SAILOR

Service Information No. 62
Kundendienst-Mitteilung No.
Service Information No.
Información de servicio No.
Servicemeddelelse No.

Date / Datum / Date / Fecha / Dato 7th February 1975

Conc. Ferrite Direction Finder 46BK (old model) in connection with the RECEIVER R108.

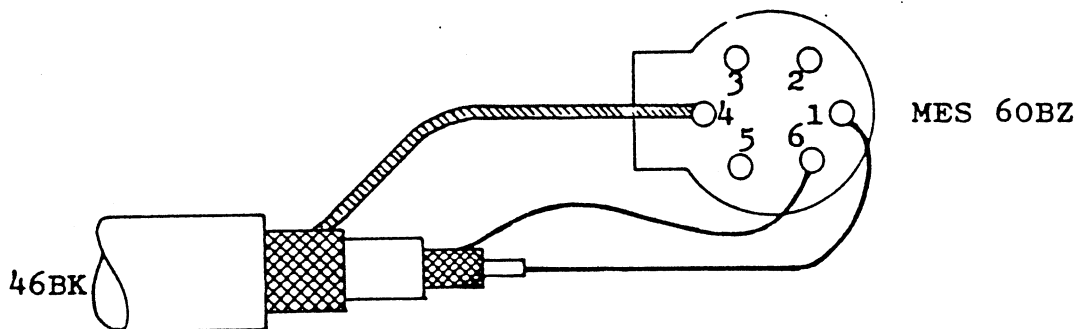
If 46BK is to be connected to the receiver, a new plug must be mounted on the ferrite direction finder.

The plug to be used is a Hirschmann MES 60BZ (which can be required from us).

The below sketch is showing the mounting.
